Date: March 6, 2024
Project: Nicetown Park Renovations
GR Project No. 2009.05

ANSWERS TO QUESTIONS/RFIS:

Acknowledgement of Addendum No. 2

Date: March 1, 2024
Project: Nicetown Park Renovations
GR Project No. 2009.05
To: Robert LaBrum, PHDC
From: Julie Bush, Ground Reconsidered
Distribution: Francesco Cerrai, PPR
Priyanka Malik, PPR

PROJECT NO.	2471-02	DRAWING NO.	C-2.1
DATE	01.19.2024	SCALE	1" = 30'-0"
DRAWN BY	KSE	CHECKED BY	RSB

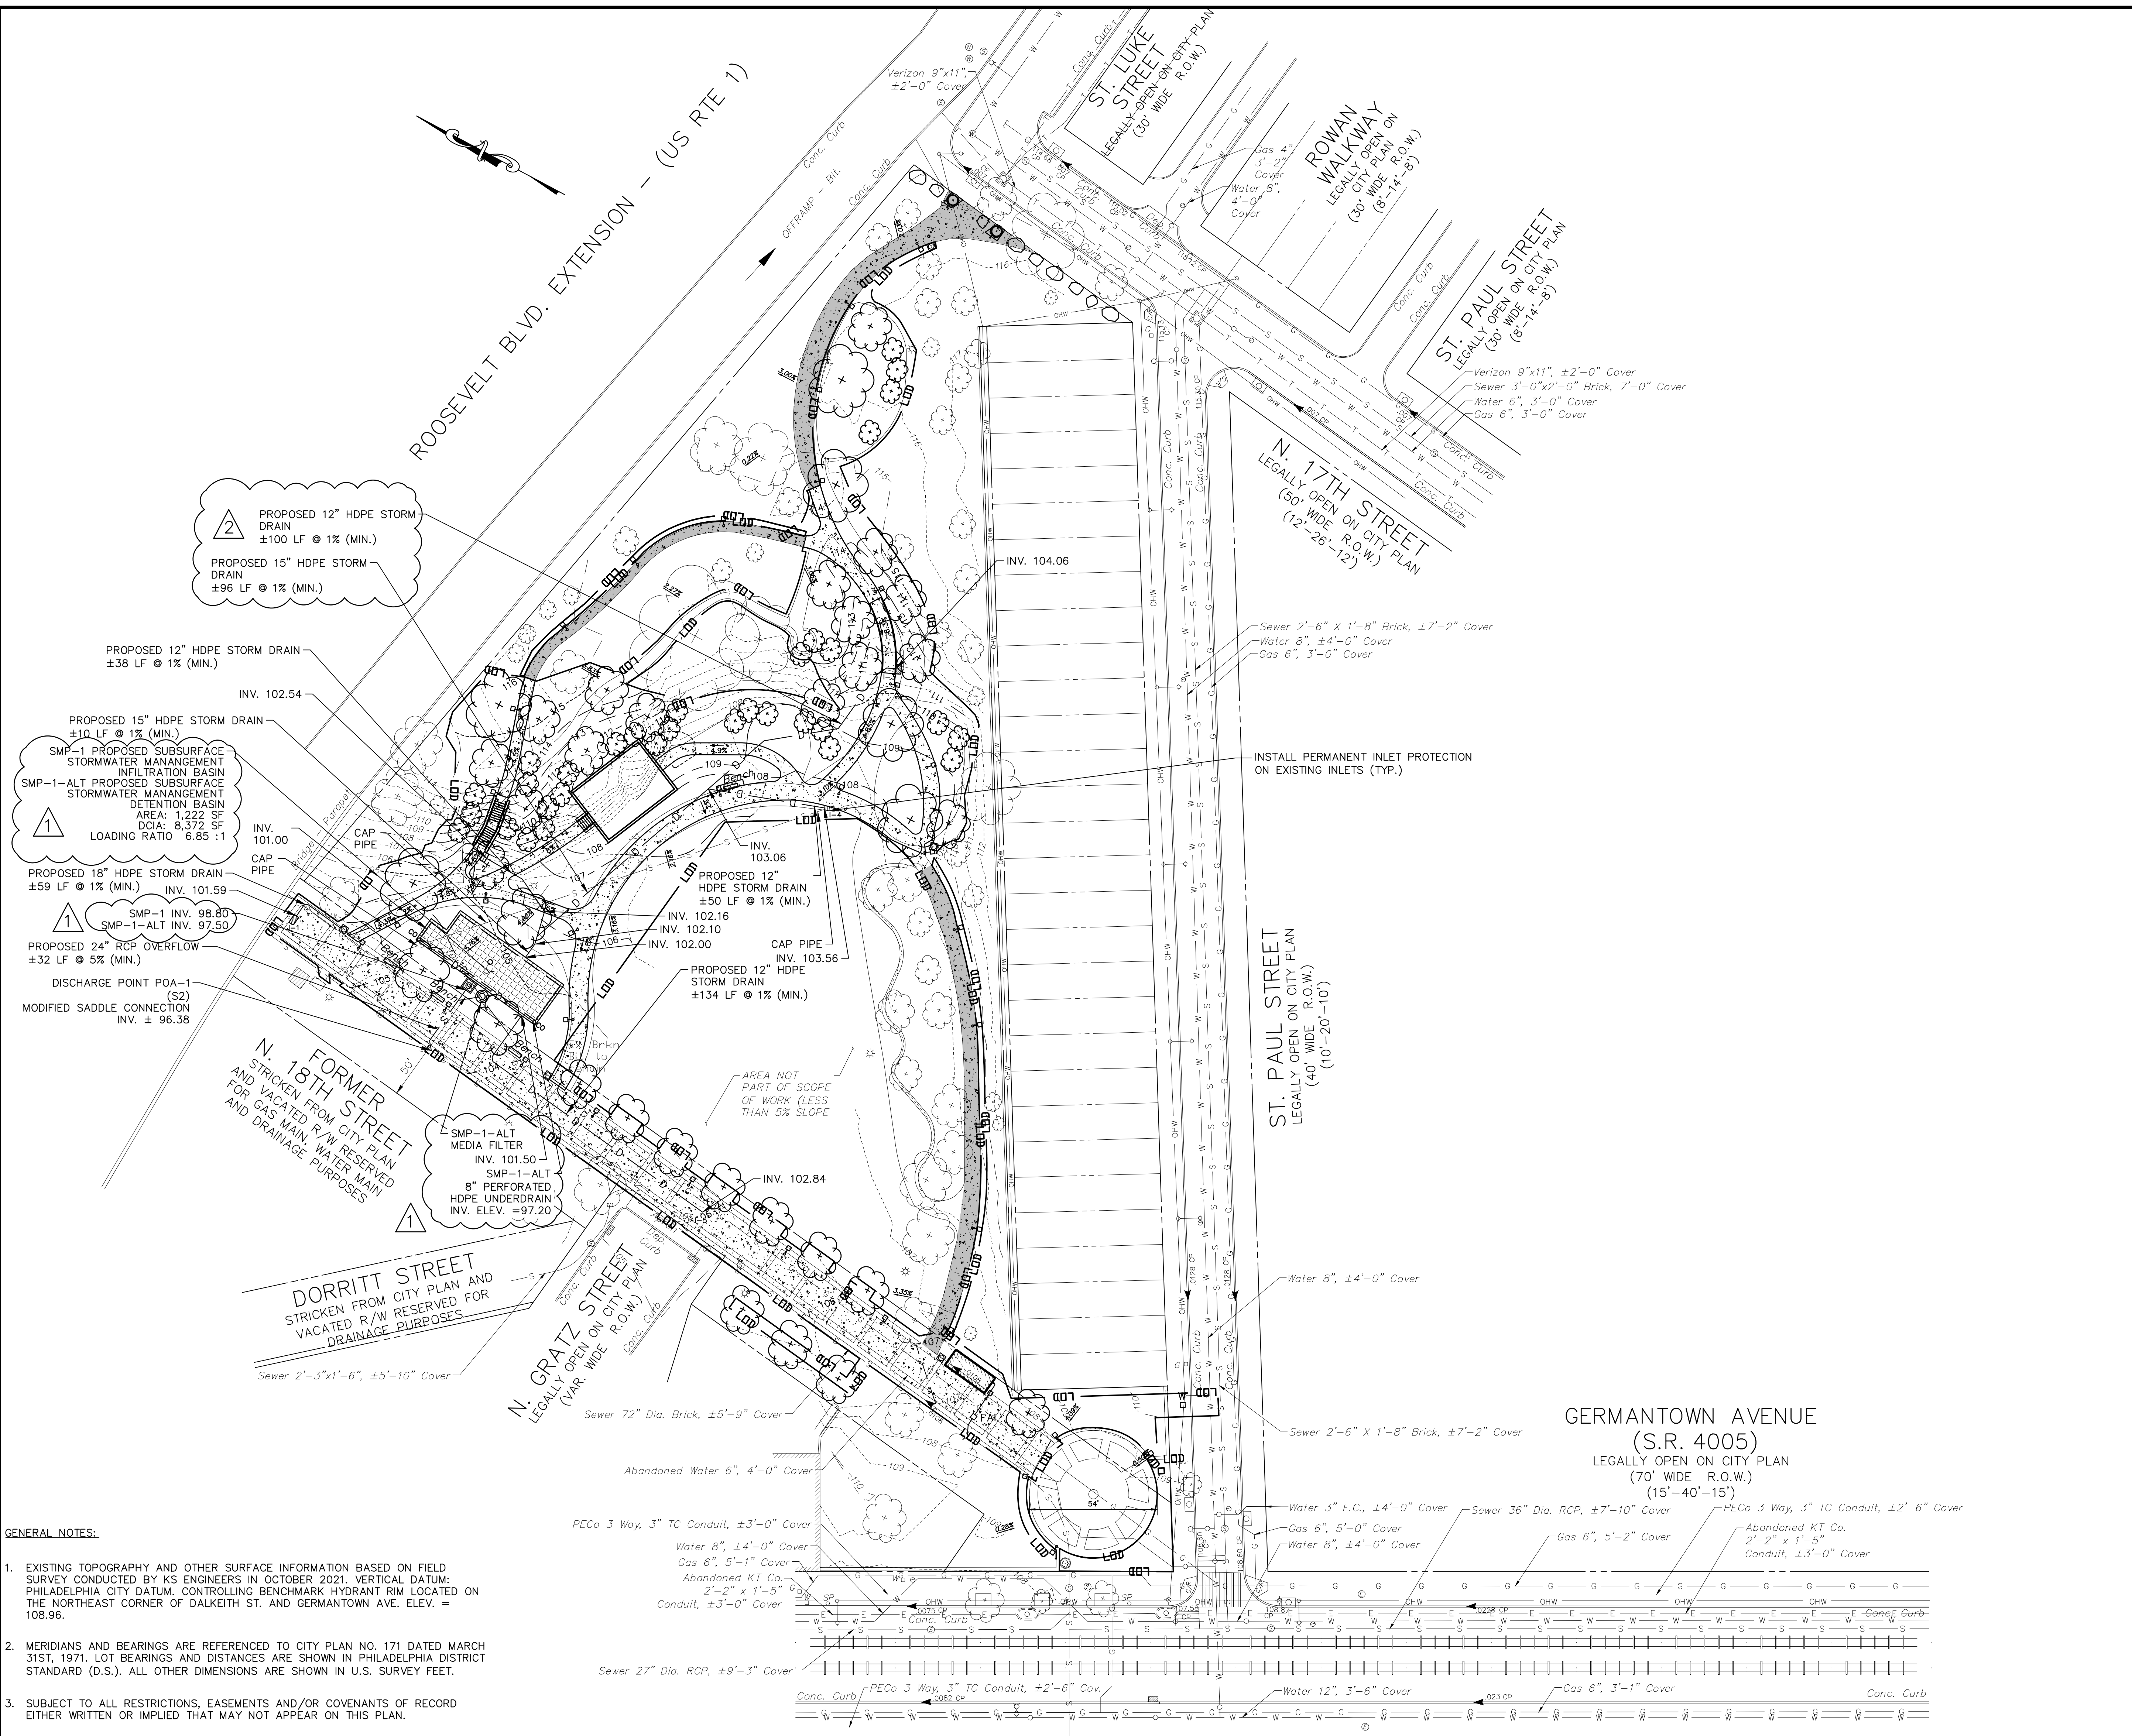
C-2.1 Stormwater Management Plan

- Updated 196' segment of 12" HDPE storm pipe to a 100' 12" pipe segment and a 96 LF 15" pipe segment for required pipe capacity
- Removed floating callout for 120' of 12" pipe from old version of design

2 PROPOSED SINGLE LINE DIAGRAM
Scale: NTS

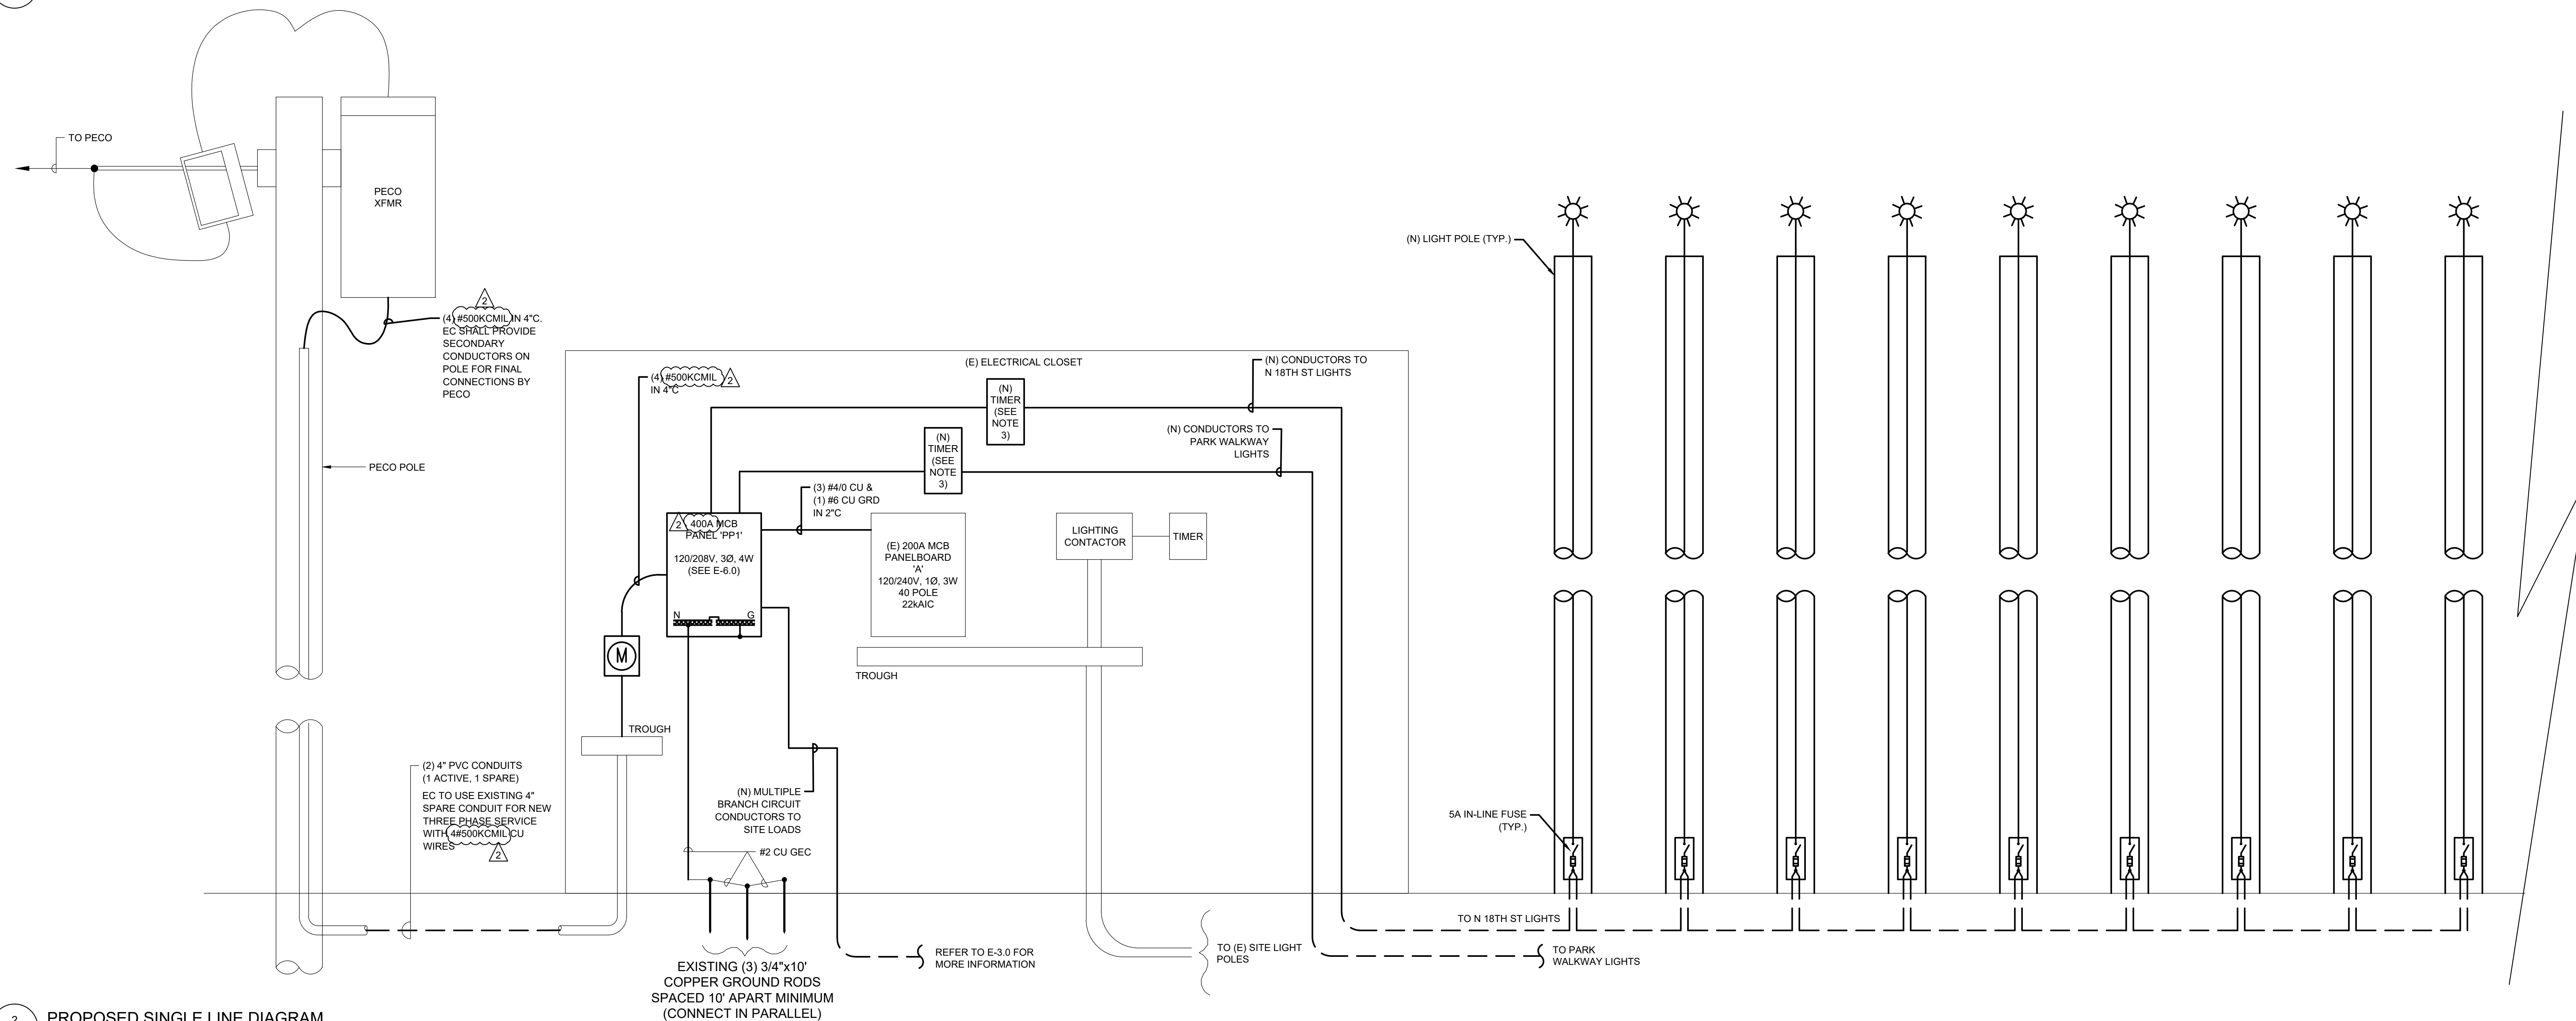
E-5.0

- Modified detail 2 to revise the electrical service feeder from 300A to 400A
 - Modified Panel PP1 to 400A
 - Modified electrical conductors from utility pole to Panel PP1

- a. Yes, detail 3/L6.4 only applies to the 2-plant beds at the Germantown entry.
4. Suppliers and PECO do not have a 300 Amp, three phase meter or meter socket. Technical Specifications do not have a section for metering. Can you provide a manu. And model number for this meter socket?

- a. Drawings shall be updated to include 500kcmil from pole to meter. Panel and meter shall be updated to 400A. See revised drawings.
5. Is a CT Cabinet required for the service? Will the new 300A panel fit into the electrical shack or will it be mounted on the exterior? We could not access the shack at the pre-bid.
